# City of Sandy

### Planning Commission Meeting

**Meeting Date:** Monday, April 22, 2019

**4 NORTH ELEVATION**  
Scale: 1/4" = 1'-0"

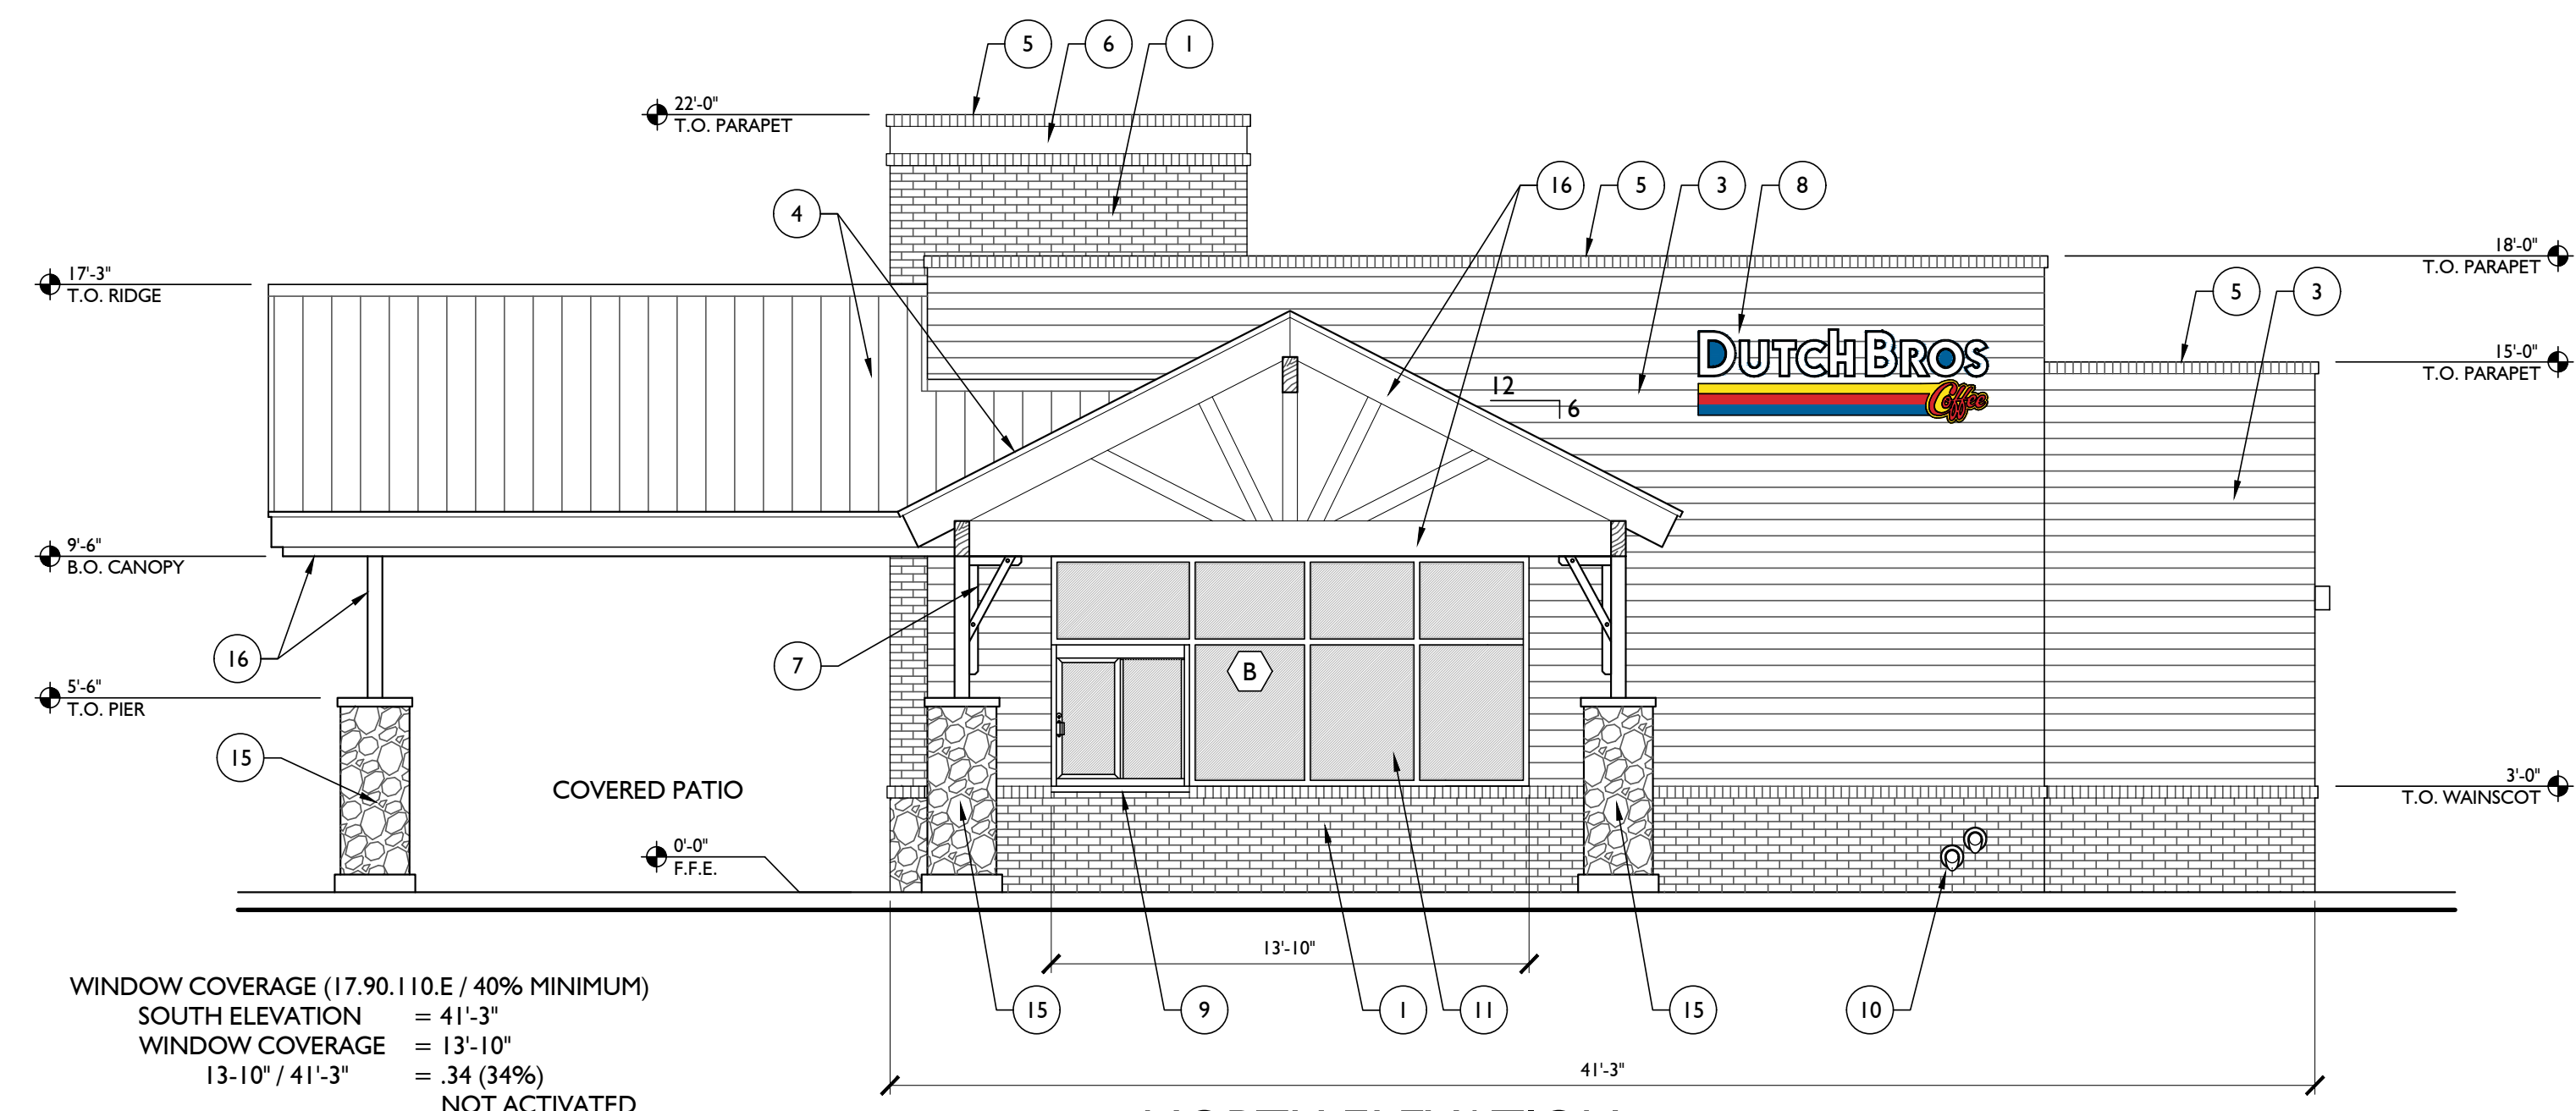
**RESPONSE:** *The proposed parking area is located adjacent to the north elevation of the proposed building. The north elevation for Building 1 (Exhibit I, Sheet A5.1) identifies windows along the eastern portion of the north façade where a pedestrian ordering window will be located and the remainder shall incorporate cohesive materials as the remainder of the building. The proposed use is unique as no internal space is proposed for patrons, therefor the proposed windows appear adequate regarding employee safety. Real windows would allow visibility from the Dutch Bros interior to the pedestrian entrance and parking area. The proposed windows along the east façade of the proposed building will allow visibility between the proposed eating and drinking assembly area and the proposed civic space. In addition, the proposal includes windows on the south façade where the pick-up window is proposed for the drive-through facility. Visibility of the civic space, parking lot and proposed drive-through from the internal assembly area is a desirable surveillance feature. **The applicant shall provide street address numbers measuring a minimum of six (6) inches high, which clearly locate buildings and their entries for patrons and emergency services. The applicant shall verify the location(s) of the address with the Building Official and emergency service providers.** On-site lighting is evaluated in Chapter 15.30 of this staff report. Lighting has been designed to illuminate driveways and building entrances.*

**RESPONSE:** The proposed parking area is located adjacent to the north elevation of the proposed building. The north elevation for Building 1 (Exhibit I, Sheet A5.1) identifies windows along the eastern portion of the north façade where a pedestrian ordering window will be located and the remainder shall incorporate cohesive materials as the remainder of the building. The proposed use is unique as no internal space is proposed for patrons, therefor the proposed windows appear adequate regarding employee safety. Real windows would allow visibility from the Dutch Bros interior to the pedestrian entrance and parking area. The proposed windows along the east façade of the proposed building will allow visibility between the proposed eating and drinking assembly area and the proposed civic space. In addition, the proposal includes windows on the south façade where the pick-up window is proposed for the drive-through facility. Visibility of the civic space, parking lot and proposed drive-through from the internal assembly area is a desirable surveillance feature. **The applicant shall provide street address numbers measuring a minimum of six (6) inches high, which clearly locate buildings and their entries for patrons and emergency services. The applicant shall verify the location(s) of the address with the Building Official and emergency service providers.** On-site lighting is evaluated in Chapter 15.30 of this staff report. Lighting has been designed to illuminate driveways and building entrances.

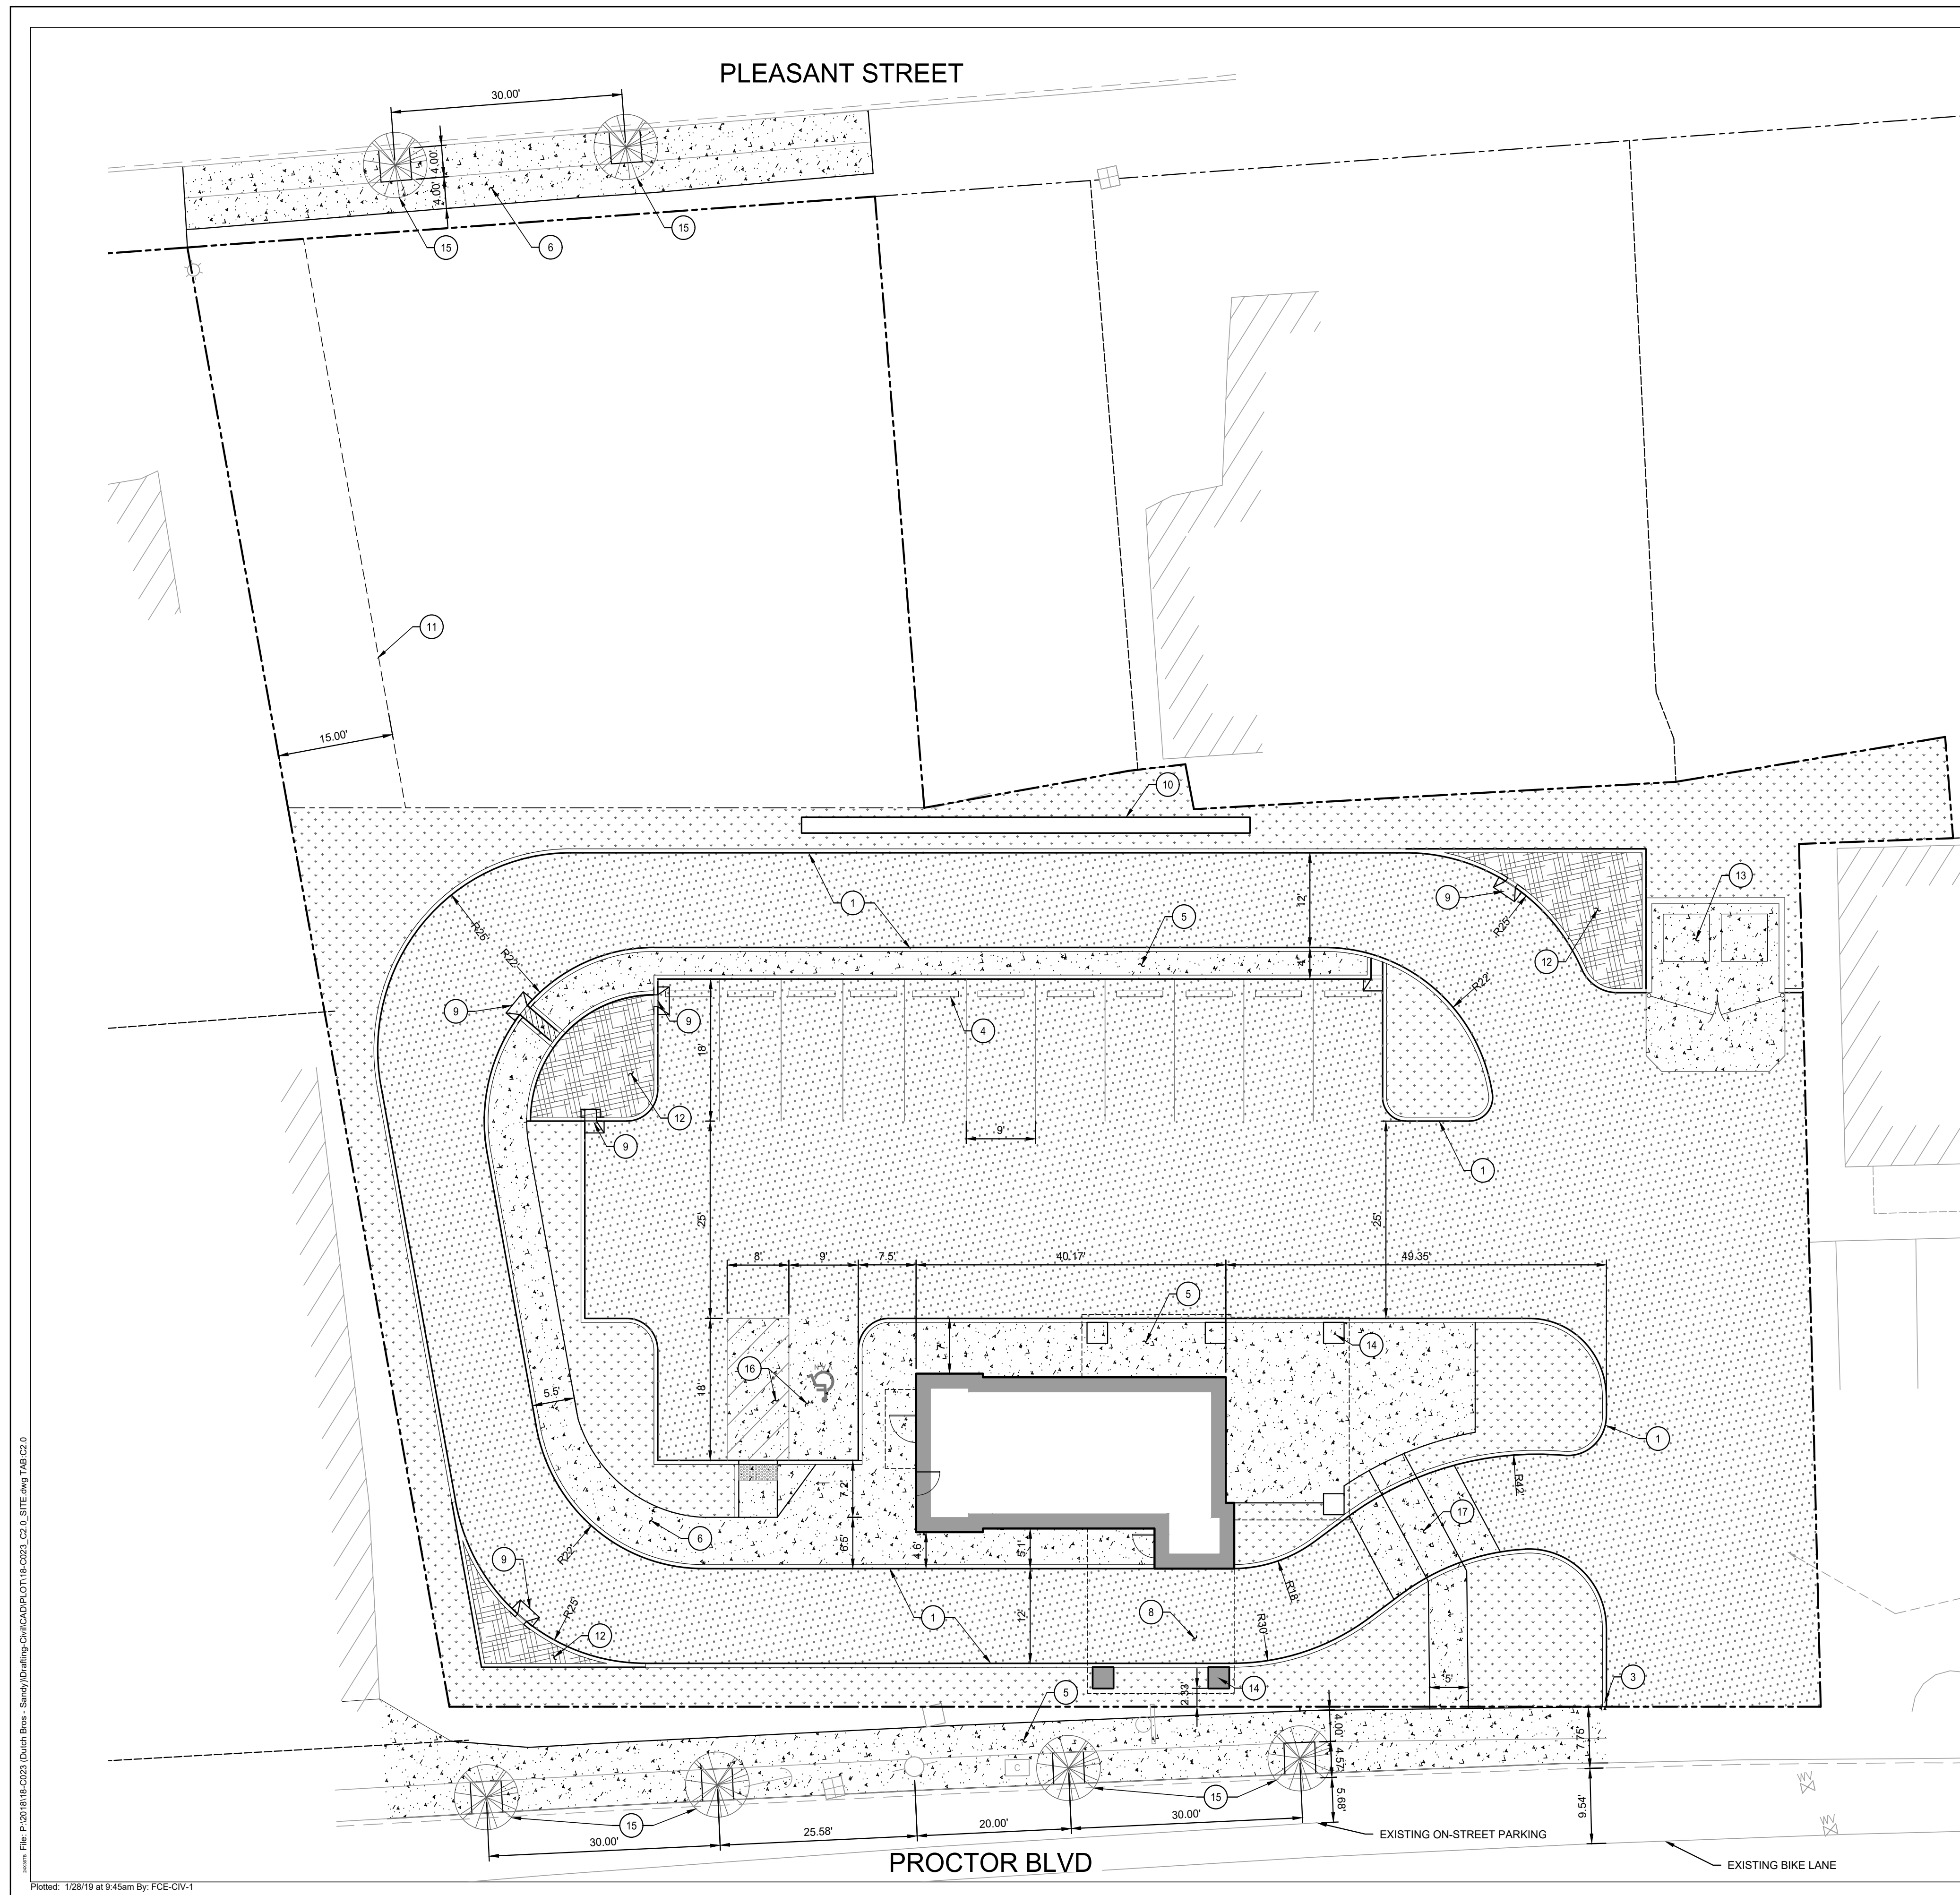
**RESPONSE:** Section 17.90.110(H.3) specifies that walkways and parking lots should be illuminated at 1.5 – 2.0 foot candles. The submitted Photometric Plan (Exhibit I, Sheet E1.0) details parking lot illumination at 0.08 to 4.24 foot candles and walkway illumination at 0.18 to 3.24 foot candles. The applicant is proposing to use a Size 1, D-Series light fixture that cascades light downward from the light fixture which will be mounted on a 15 foot tall pole. **The applicant shall update the proposed parking area lights with lights that have a smaller distribution and emit less intense light and shall add pedestrian scale lighting along the walkway between the civic space and right-of-way as well as along the pathways adjacent to the building's façade such that they are illuminated at 1.5 – 2.0 foot candles.** All outdoor lighting systems has been designed so that the area 10 feet beyond the property line of the premises receives no more than .25 (one quarter) of a foot-candle of light from the proposed listing system. Lighting is discussed further in Chapter 15.30 (Dark Sky) of this document.
